Proposed Upgrade to Masterton Wastewater Treatment Plant

Response to Further Information Request by the Greater Wellington Regional Council

Appendix 1a: Proposed Homebush Effluent Disposal Site Soils

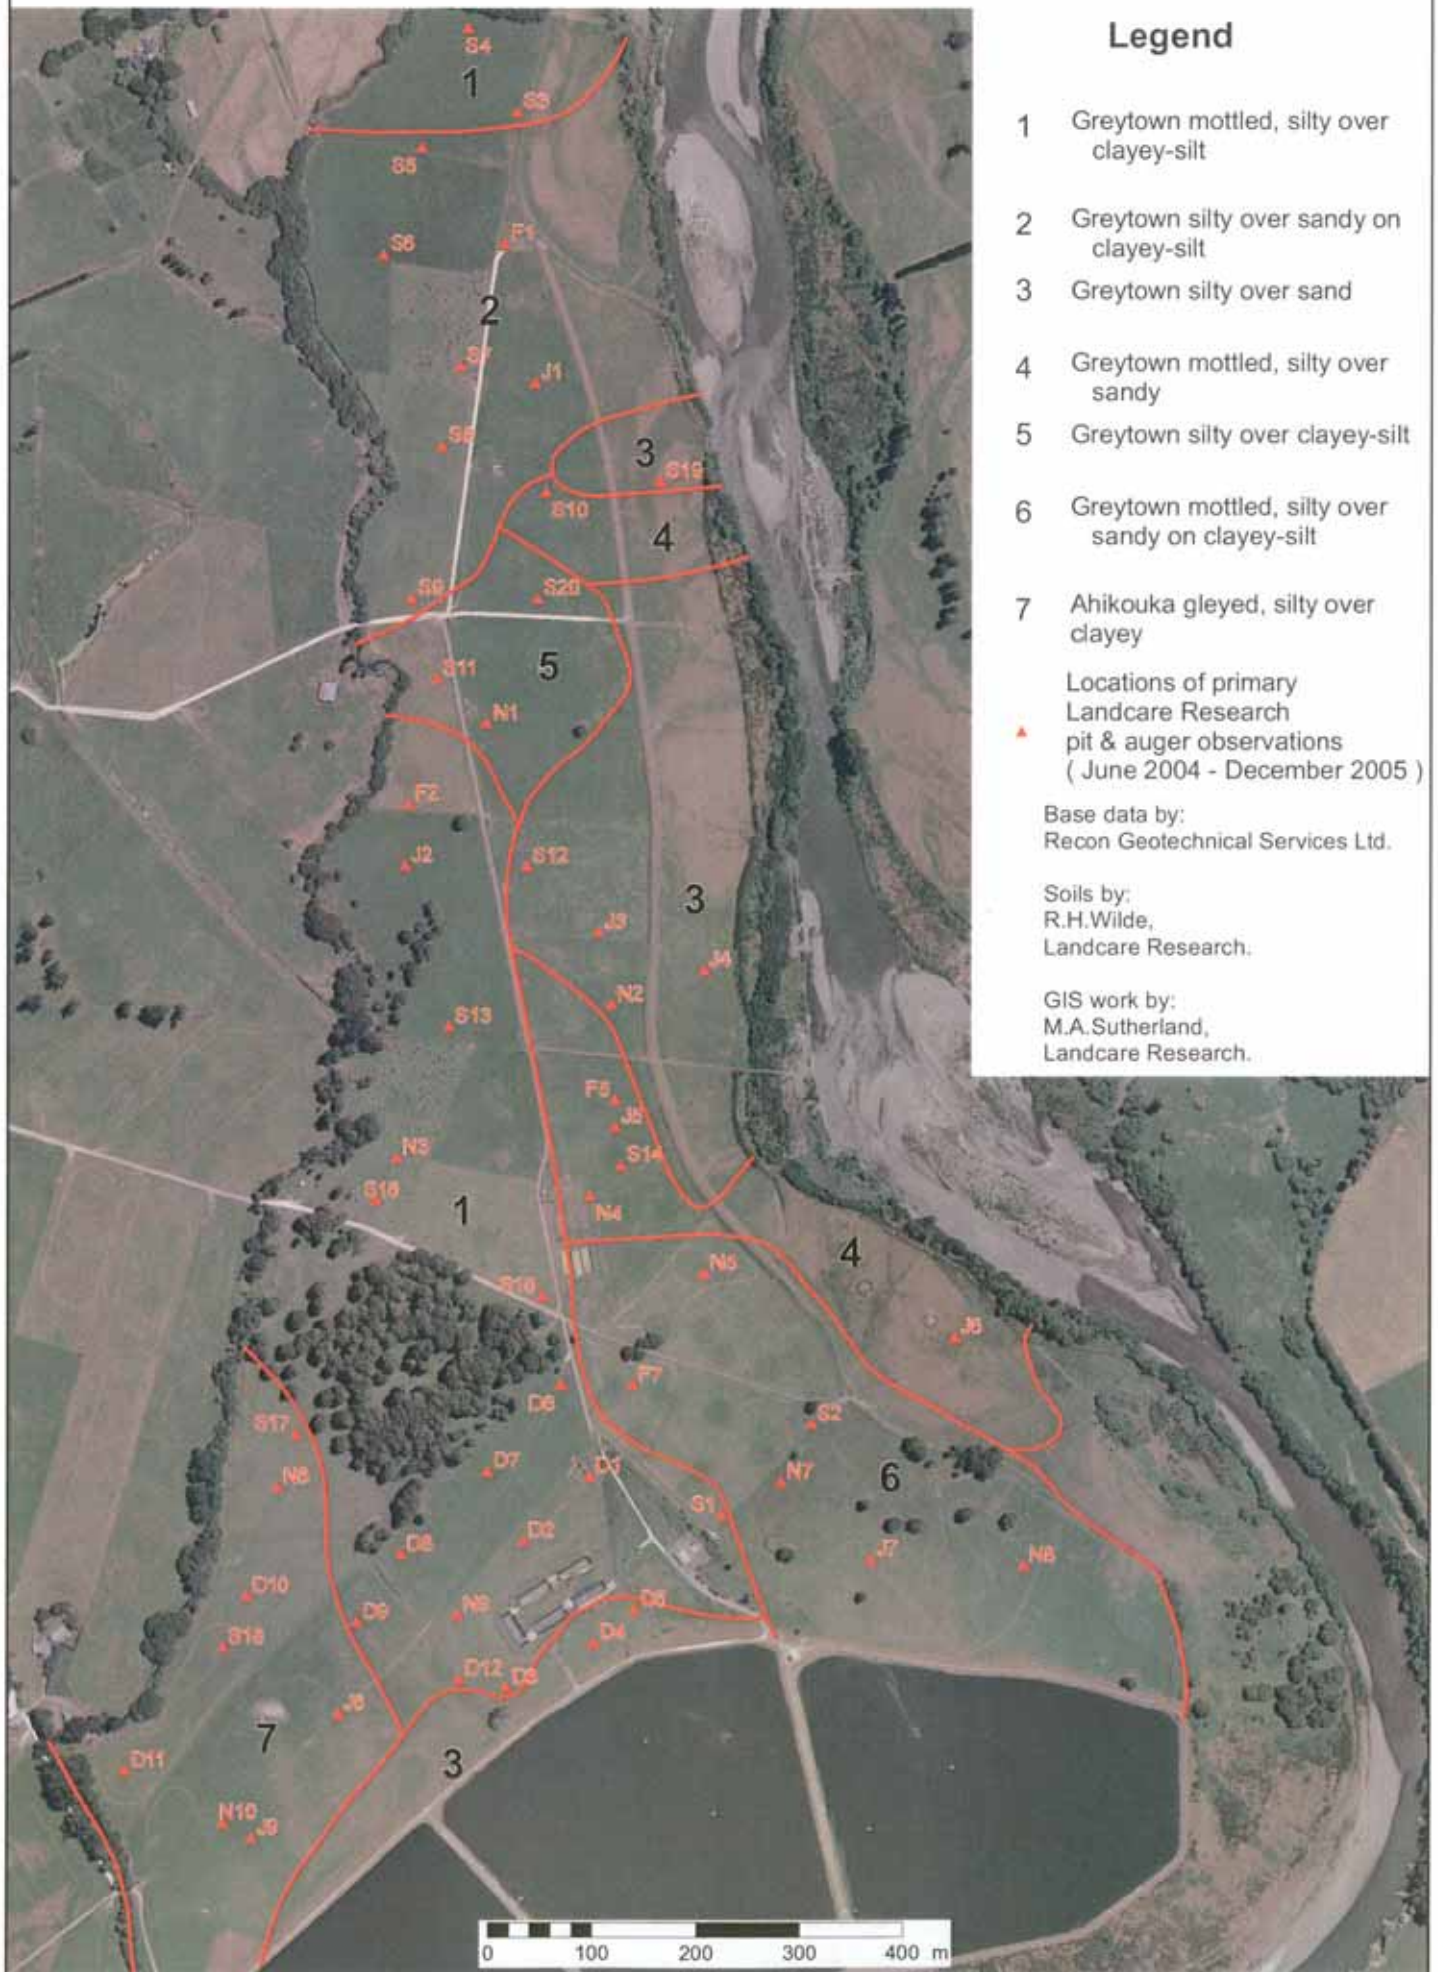
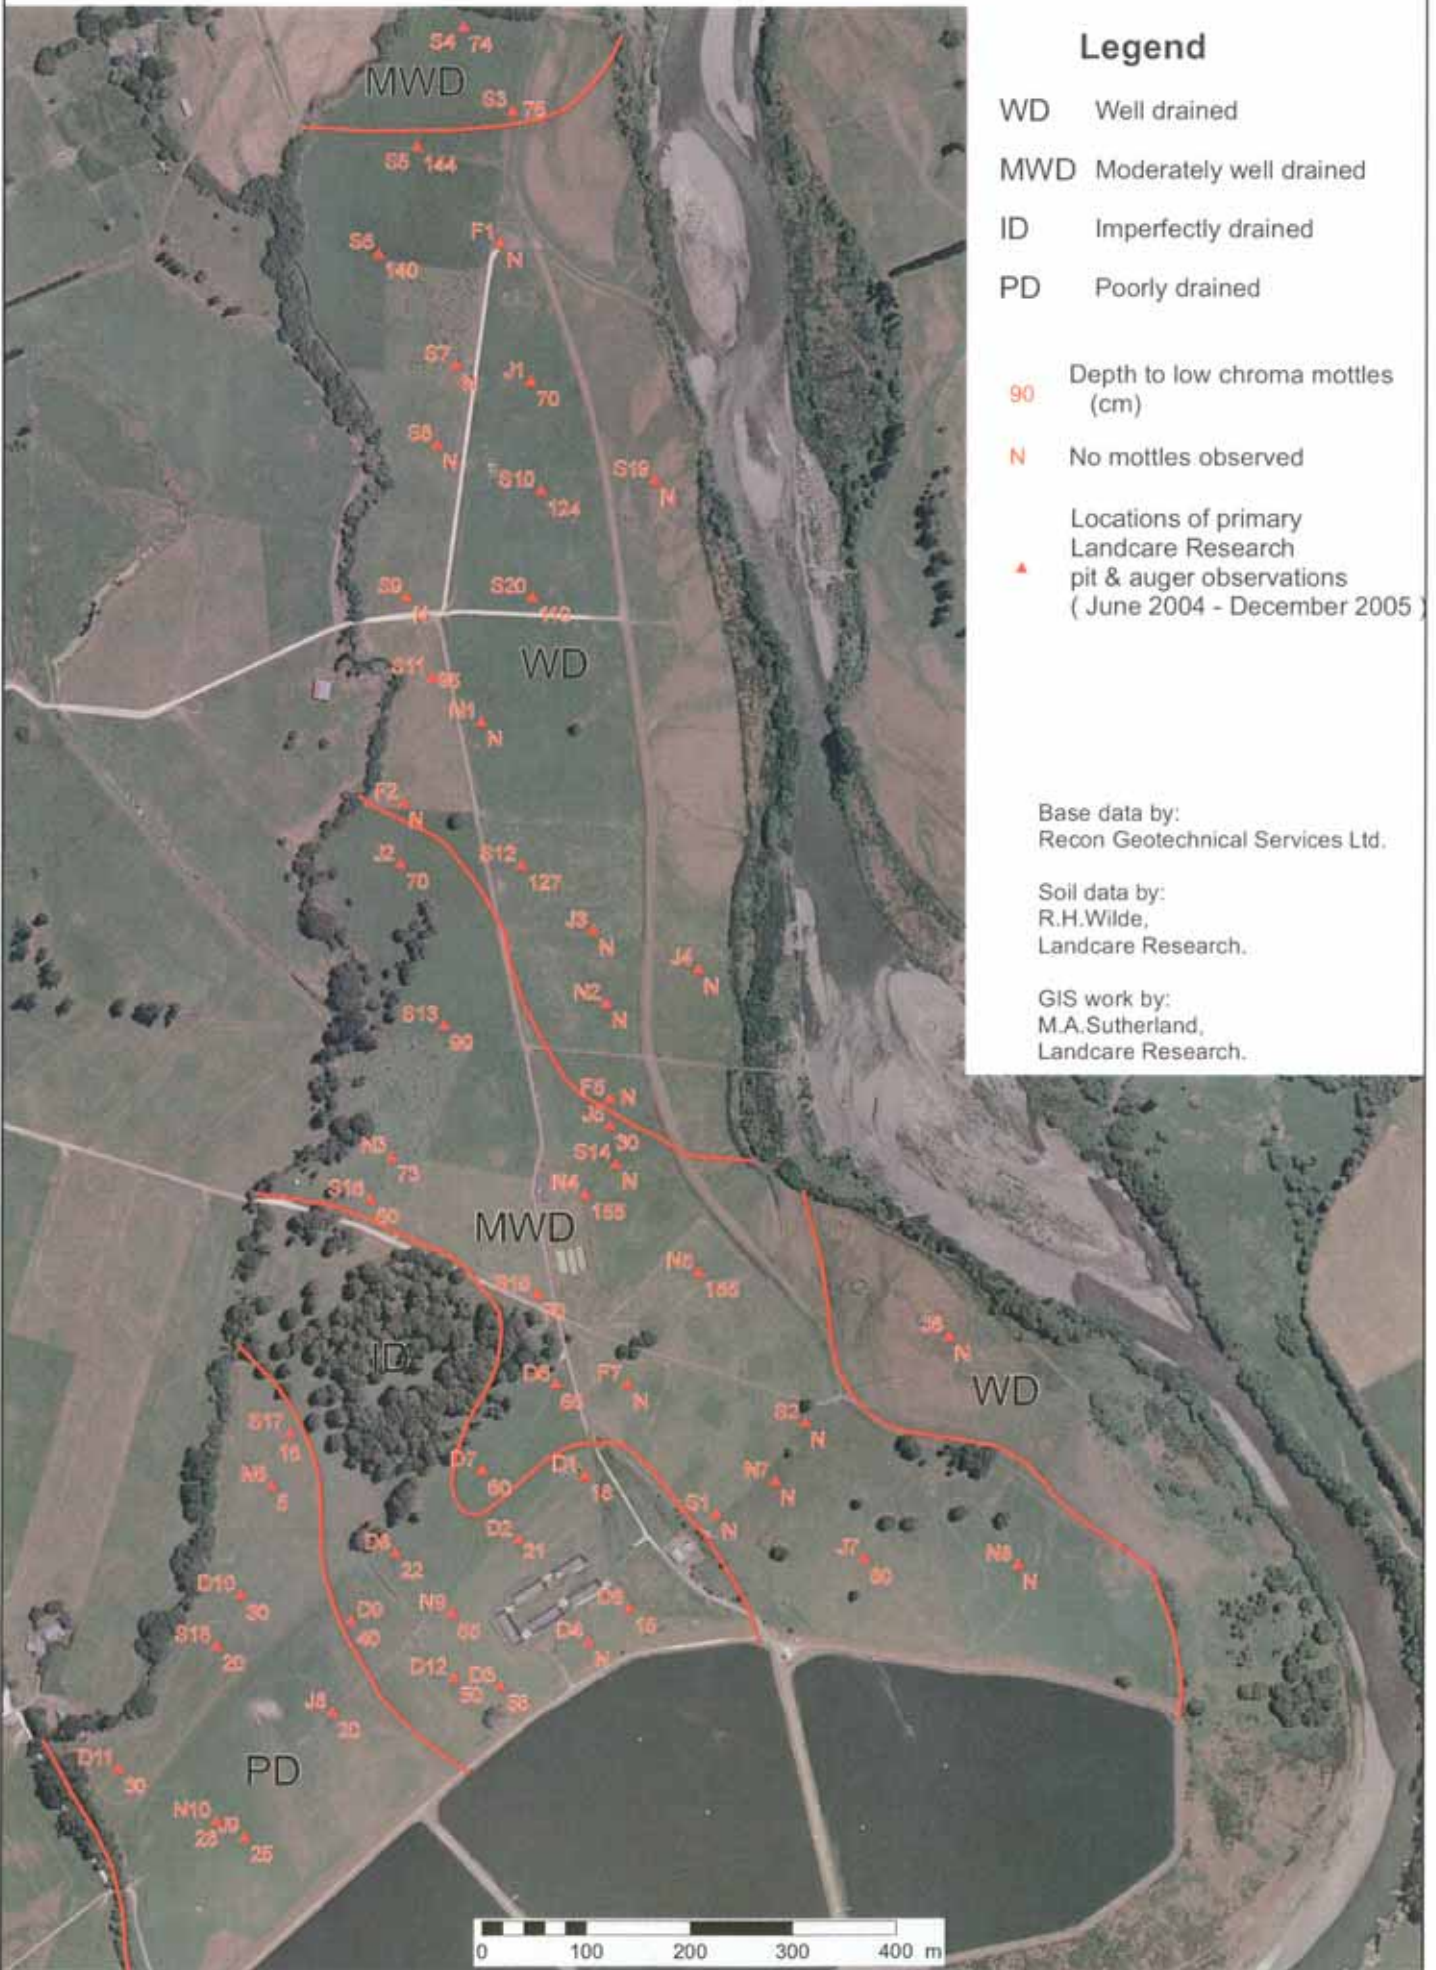
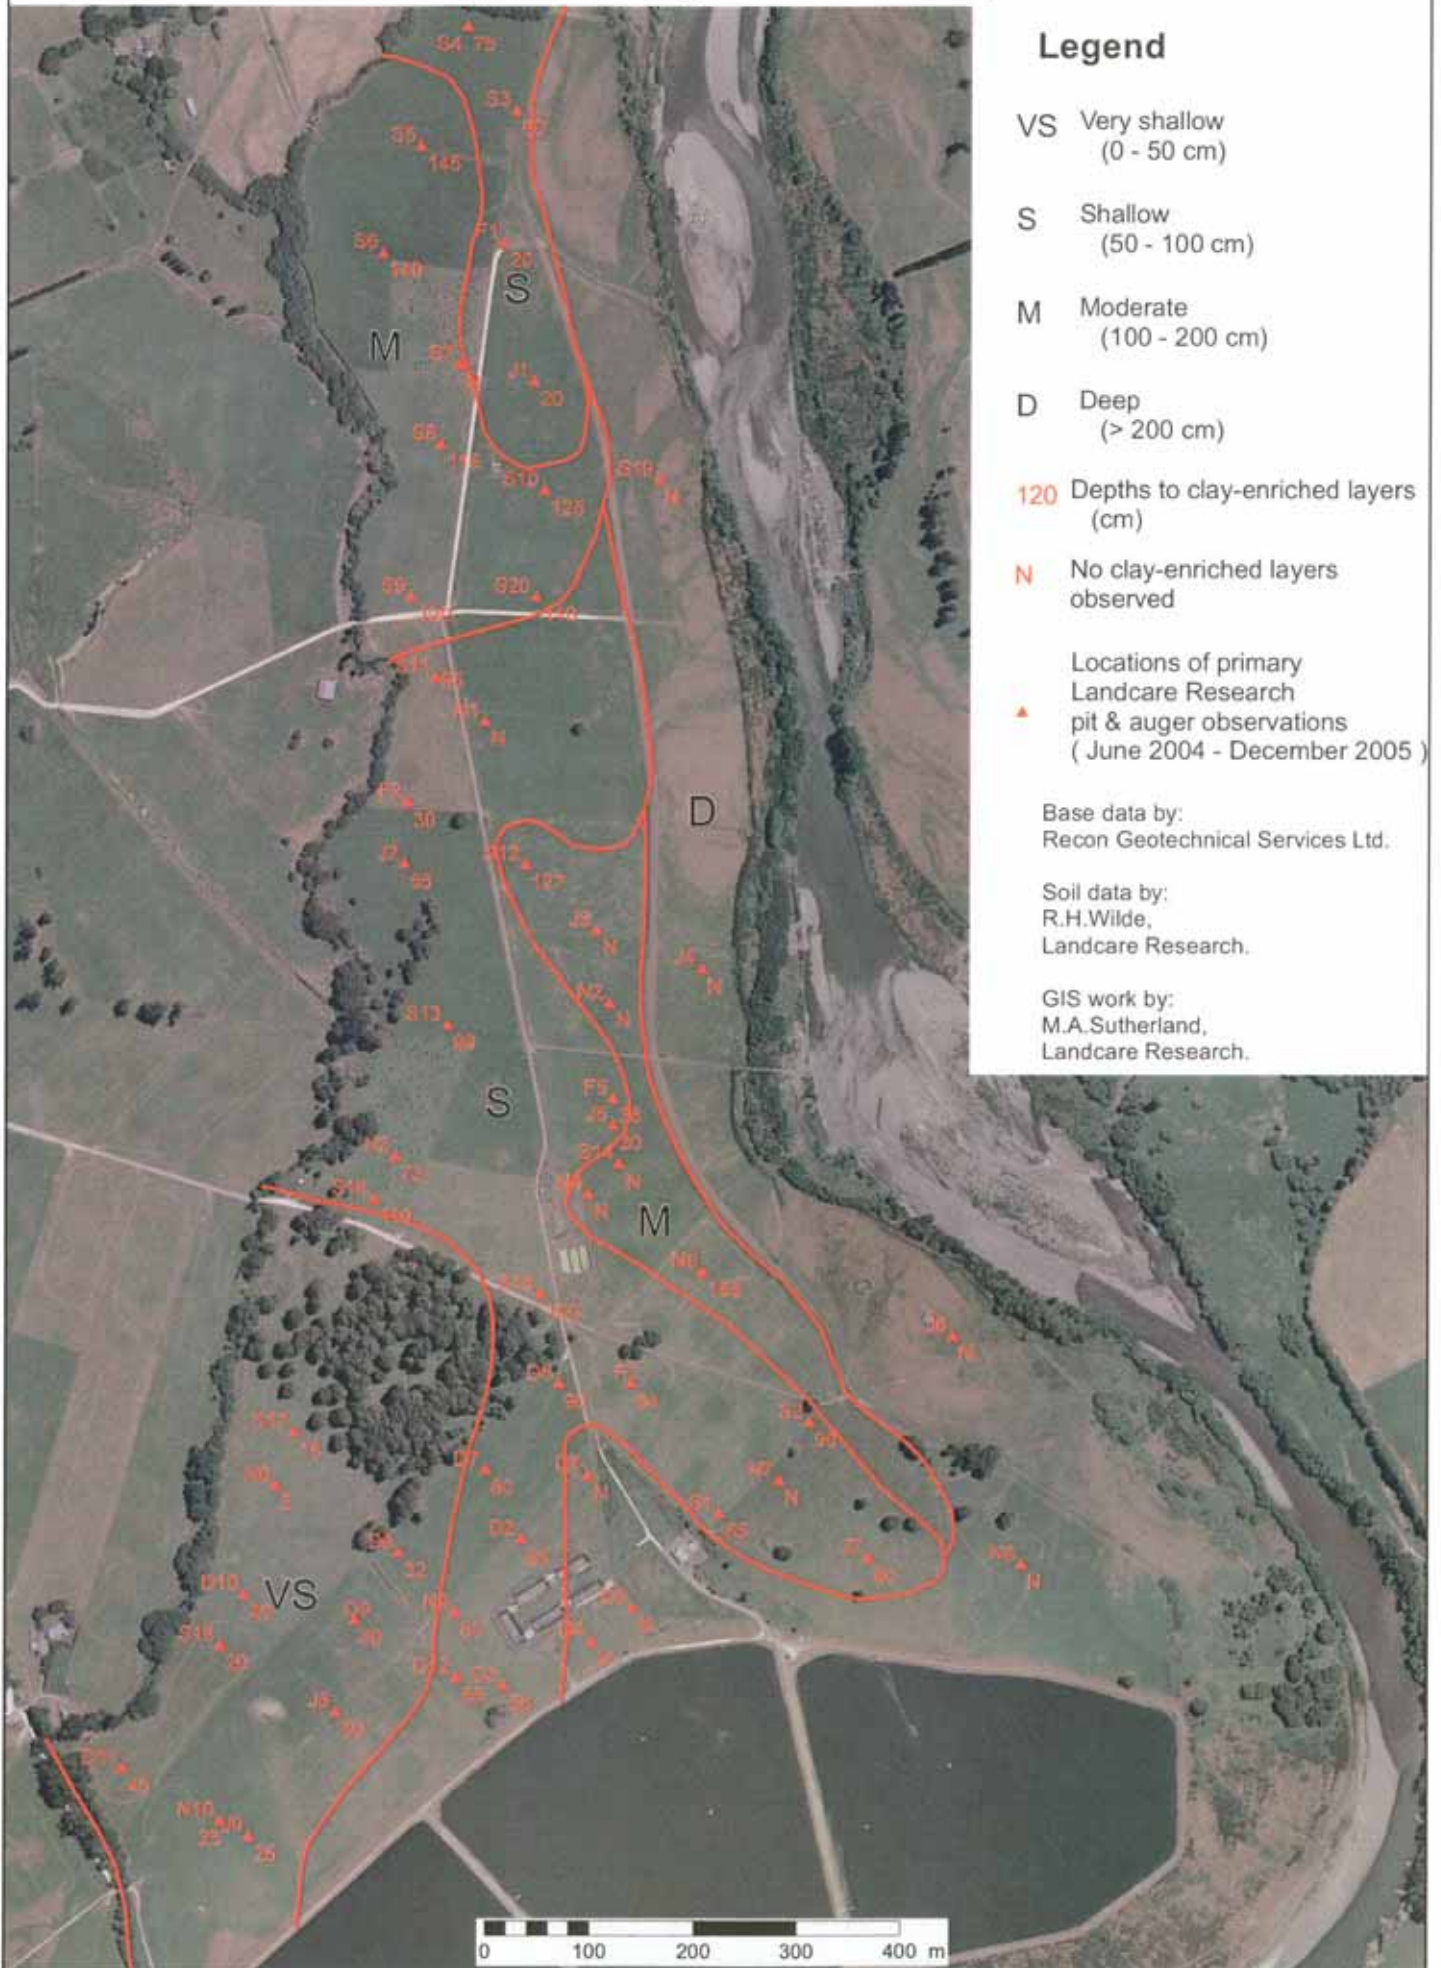
Please provide a clear map of the soils on the site.

p.51 of the AEE refers to Figure A3.1 in Appendix A3 but it is not possible to read the writing on this figure.

The text in the AEE refers to the extent of the soils investigations on the site which is shown on Figure A2.1 (not Figure A3.1 which shows the irrigation site layout). The soil types are shown on the Landcare Research plan Appendix 1a to 1e, which are included in Appendix H.
